**CITY OF MALIBU
NOTICE OF INTENT TO ADOPT
A MITIGATED NEGATIVE DECLARATION**

Project Title Malibu Memorial Park

City of Malibu
Initial Study Environmental Checklist Form

FIGURE 1a

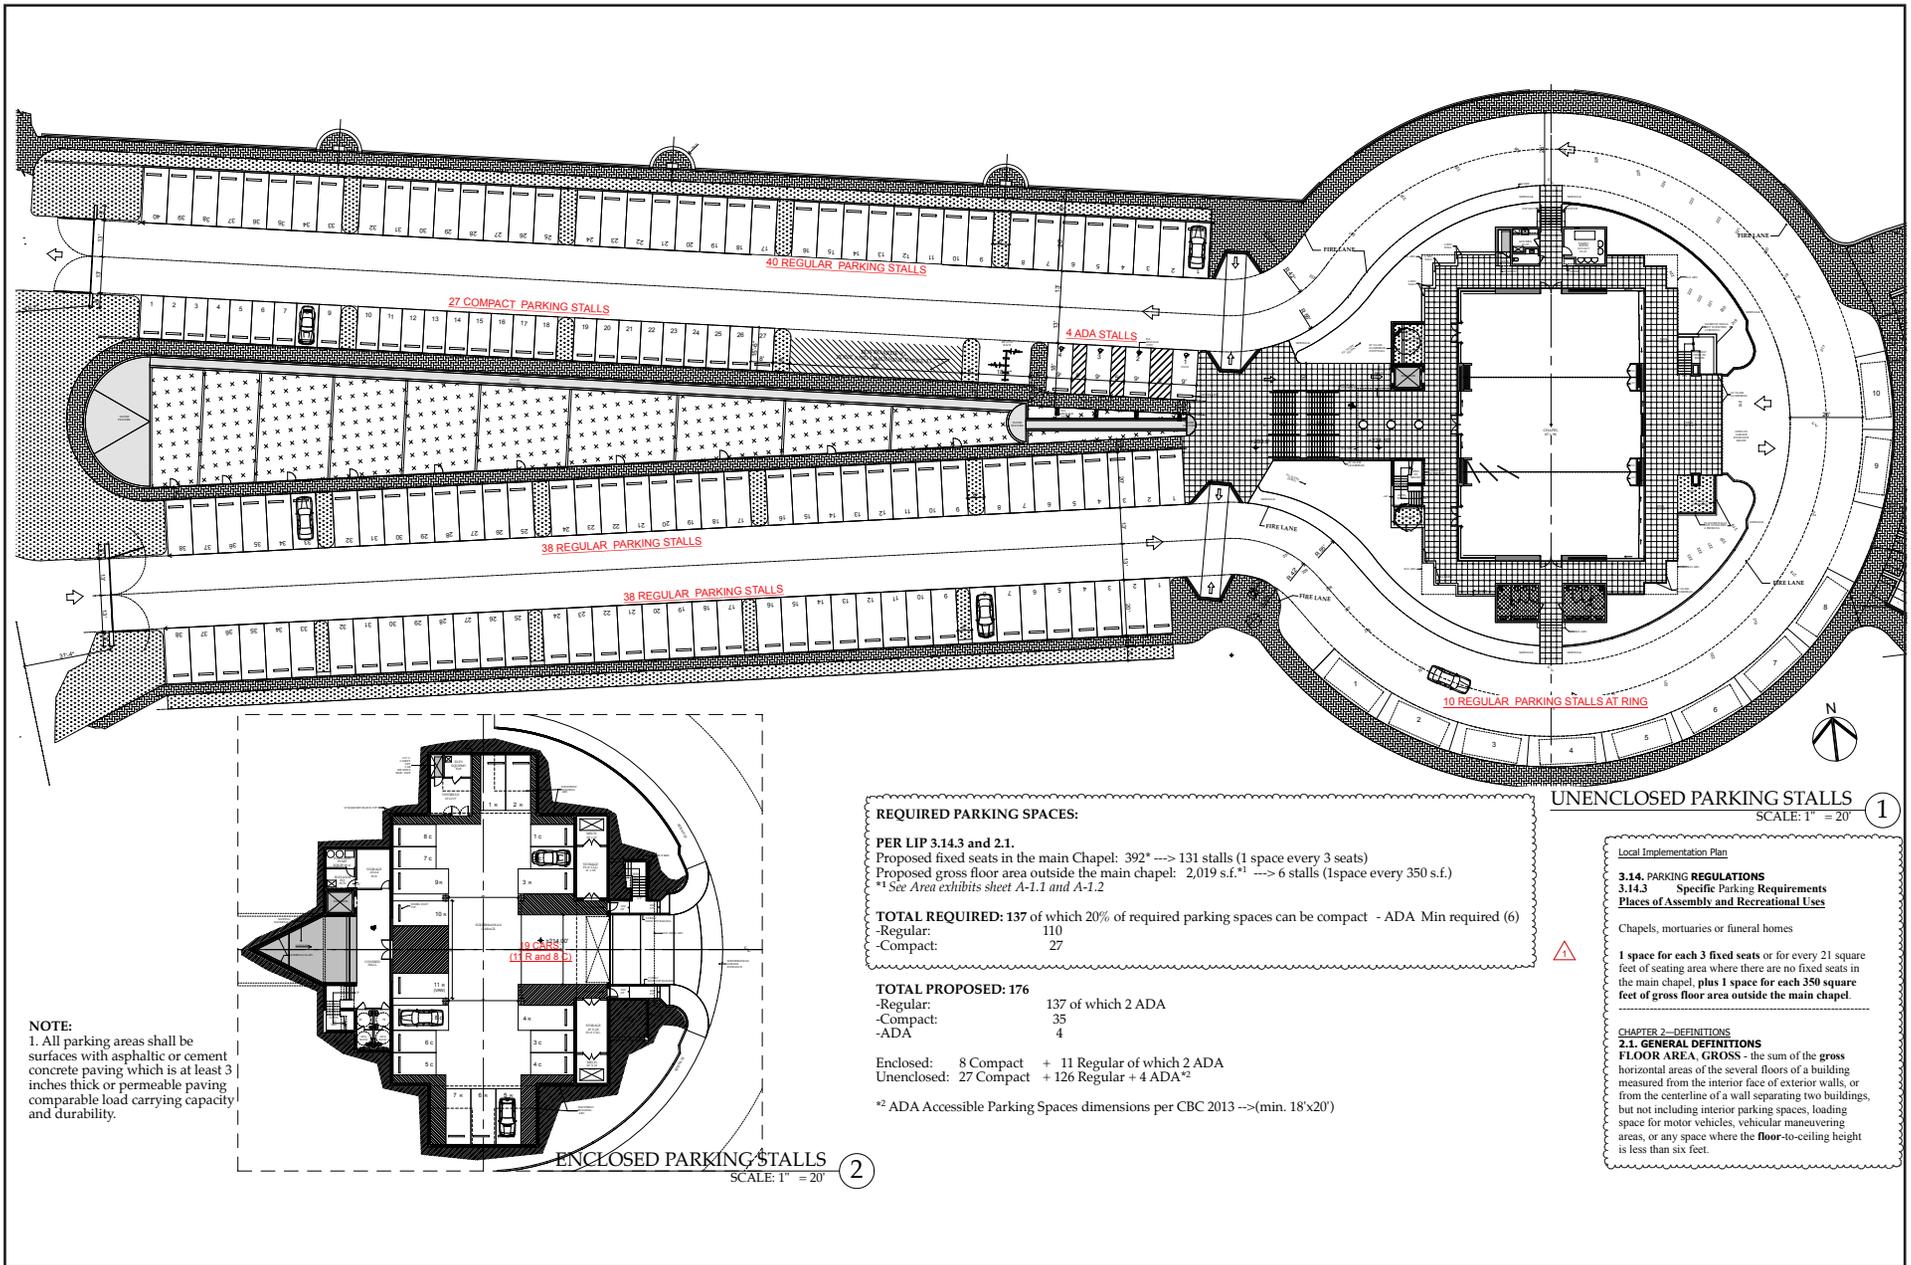
- **Page 11, Figure 1a:** In some of the digital versions of the Initial Study and MND, the “Impact Sciences” name/logo is pasted over Figure 1a, almost completely obscuring it. Please correct.

Figure 1a, Proposed Project Site Plan on page 11 has been revised.

Figure 1a, Proposed Project Site Plan on page 11 has been revised to show how some of the mausoleums were relocated to limit their visual impact.

FIGURE 3

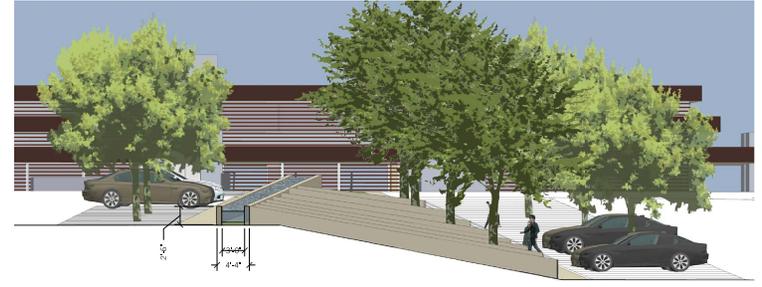
e. The landscaping plant list in Figure 3 contains some toxic plant species and some invasive plant species, as well as other problems. These plant species pose a significant threat to the ESHA and to all wildlife depending on this site for survival.

2) Suggestions for native plants to replace those non-native plant species listed on Figure 3.

- **Page 15, Figure 3:** The Proposed Project Landscape Plan has been revised and updated.
- **Page 18, Figure 6:** There is a typo in the key – “Educational Facilities” is misspelled. Please correct.

Tree and plant selections have been revised to be mostly native plants with the exception of the boxwood hedges for some of the topiaries, refer to Figure 4a, (Revised) Proposed Project Landscape Plan. Standard conditions of approval prohibit the use of invasive species.

Figure 3, Proposed Project Landscape Plan on page 15 has been revised and updated, refer to **Figure 4a, (Revised) Proposed Project Landscape Plan.** .

Figure 3, Proposed Project Landscape Plan on page 15 has been revised and updated to demonstrate that the plant palette has been revised to incorporate almost entirely native species.
